ON-SITE SEWAGE DISPOSAL SYSTEM HOWARD COUNTY HEALTH DEPARTMENT BUREAU OF ENVIRONMENTAL HEALTH

SUBDIVISION: Westside LOT NUMBER: 15

ADDRESS: 5912 Clifton Oaks Drive PROPERTY OWNER: Kenneth Blake

This office has received your building permit # 27879.
We are unable to approve your permit for the following reason(s):

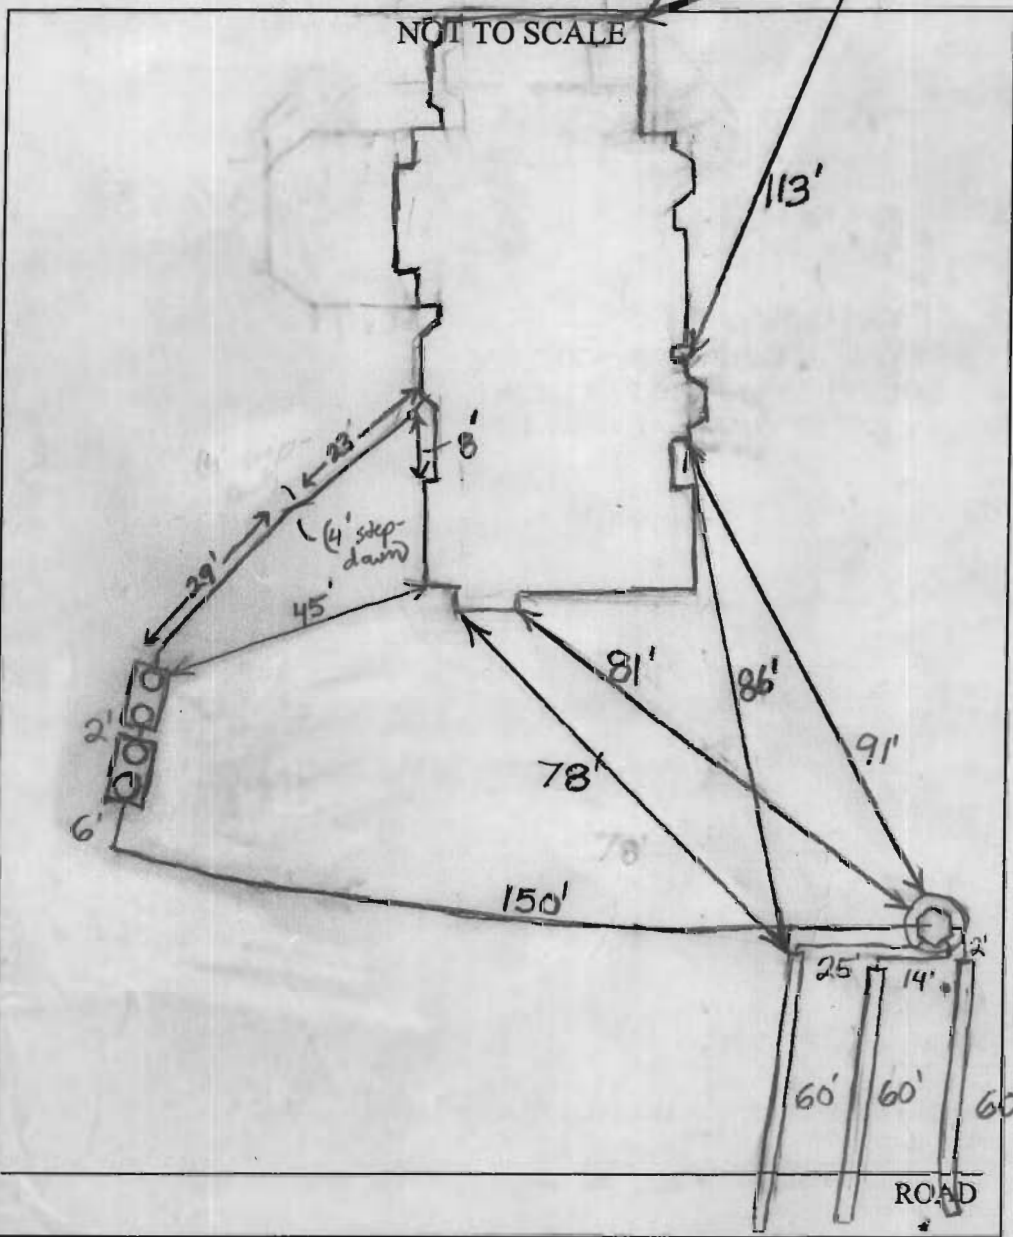
PRE-CONSTRUCTION 12/29/06 septic area out staked. No trench layout given. Told contractor ok to set tanks. Call for INSTALLATION layout after easment is staked (KW)

1/2/07 Plumbing from house to S.T. installed. Both tanks installed per installation. Contractor to set D box deep left corner of P/A. Run 3 @ 60' trenches 12' center on center. Stay w/ in easment for well set tanks (KW)

1/3/2007 Need pump and alarm test. O.K. to backfill (RB)

10/19/07 P/A OK. OK to cover.

WESTSIDE LOT 15 51212 CLIFTON OAKS DR

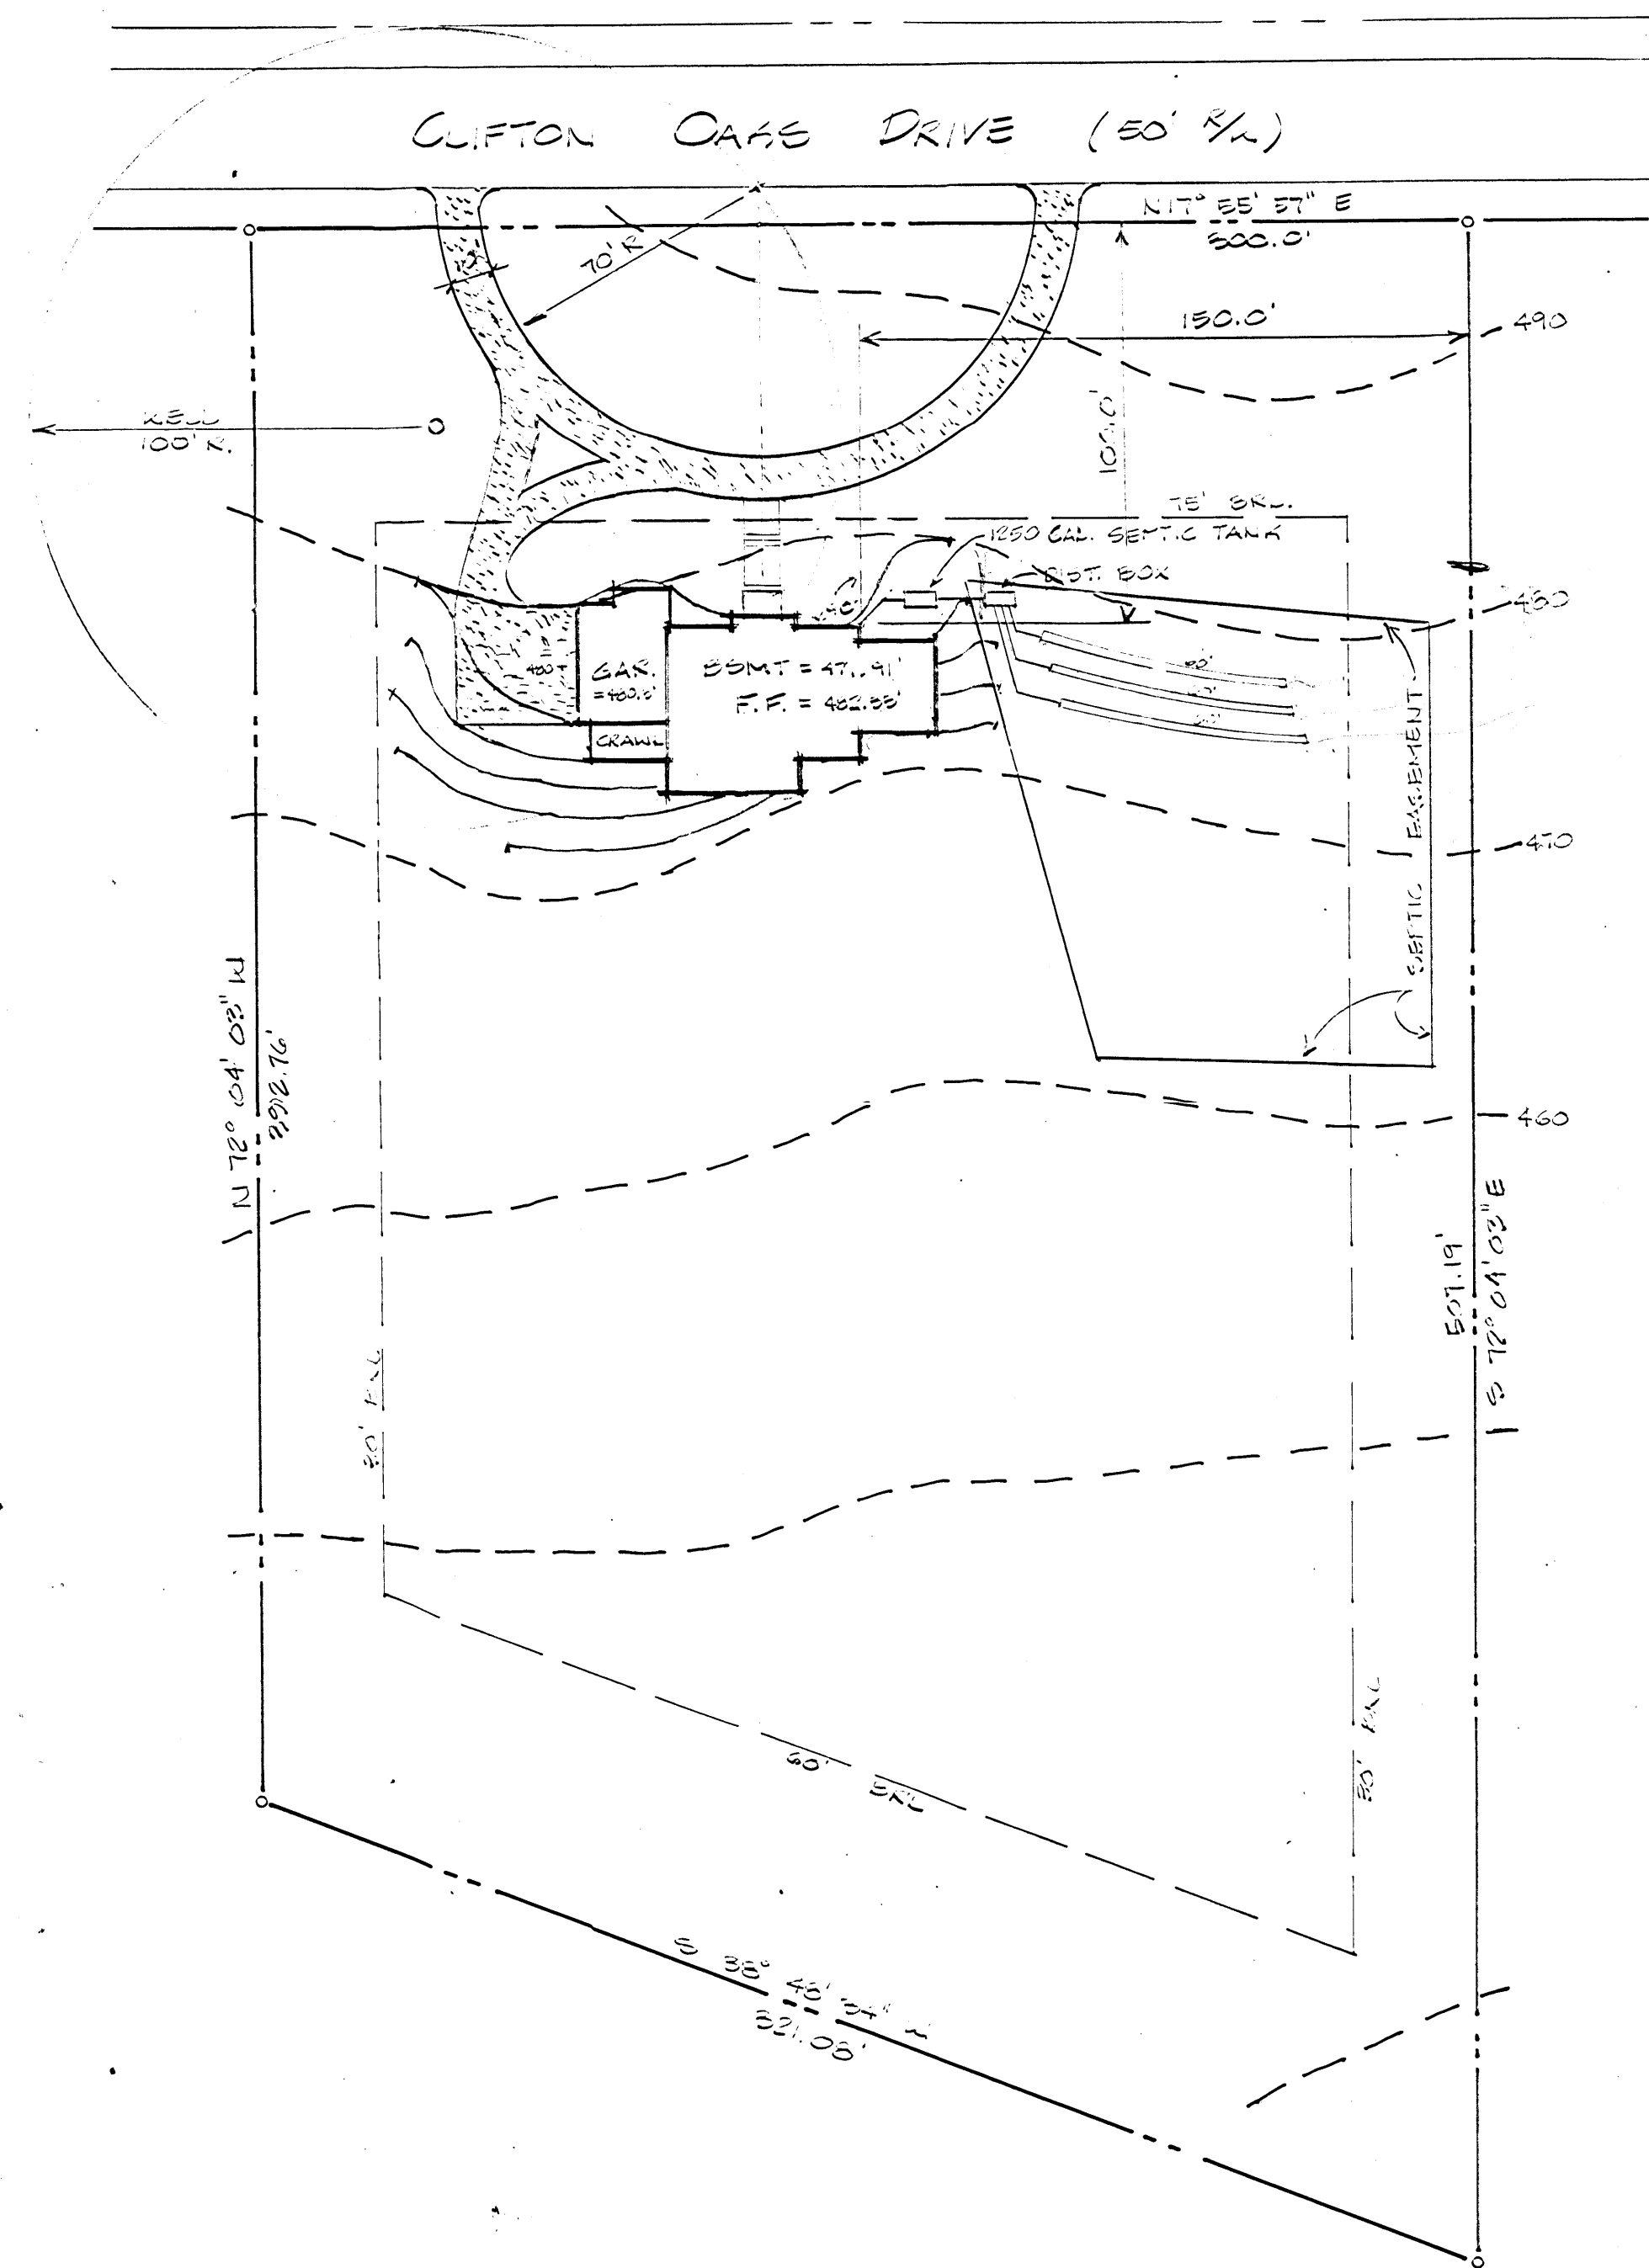
- No septic elevations/site plans provided (example and septic specification enclosed).
- Incorrect septic specs. (See enclosure.)
- No invert elevation at _____.
- No existing grade at _____.
- No elevation at well.
- Invert at trench(s) incorrect. (See enclosed.)
- House too small.
- House to _____ less than _____ feet.
- Well to _____ less than _____ feet.
- Sewage easement location incorrect.
- No well on property.
- Other: NAME ADDRESS & PHONE NUMBER NOT ON PLAT
SCALE USED NOT SHOWN, DISTRIBUTION BOX
IN WRONG LOCATION

9/1/89
Revised Plans OK
P.J.
